Product Change Notification

Change Notification #: 114290 - 01
Change Title: The Intel® Ethernet Server Adapter I340-T2 and i340-T4 OEM Generic, Product Codes: E1G42HTG1P20, MM# 904277, E1G44HTG1P20, MM# 904267 and Intel® Gigabit ET Dual and ET2 Quad Port Server Adapter, OEM Generic, Product Codes: E1G42ETG1P20, MM# 897969, E1G44ETG2P20, MM# 907808
PCN 114290-01, Transport Media, Label

Shipping Carton Update, Regulatory Mark and Label Update,
Reason for Revision: Modify text in label combination to include FCC.

2. Australia Regulatory Mark Change

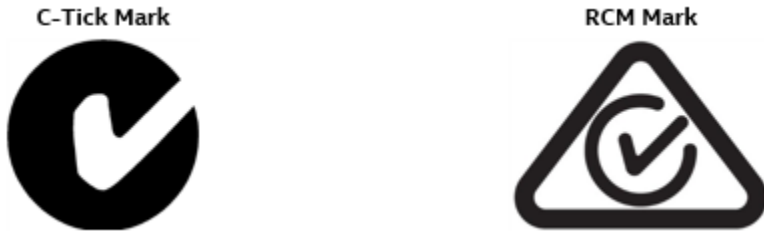
- The Australian Communications and Media Authority's (ACMA) labeling arrangements to reflect regulatory compliance changed on 1 March 2013, to be phased in over a three-year transition period. Products shipping March 1, 2016 need to be labeled with the "RCM" mark.
- Per ACMA requirements, Intel will be changing the C-Tick regulatory mark on all products to the "RCM" mark.
- Mark will be updated in two ways, depending on how the current C-Tick mark is already on products:
 - If C-Tick mark is currently on PCB silkscreen, Intel will apply a label with RCM mark to cover current mark.
 - If C-Tick mark is currently printed on a label, Intel will replace the mark so labels will be printed with new mark.
- See for picture of "C-Tick" versus "RCM" mark
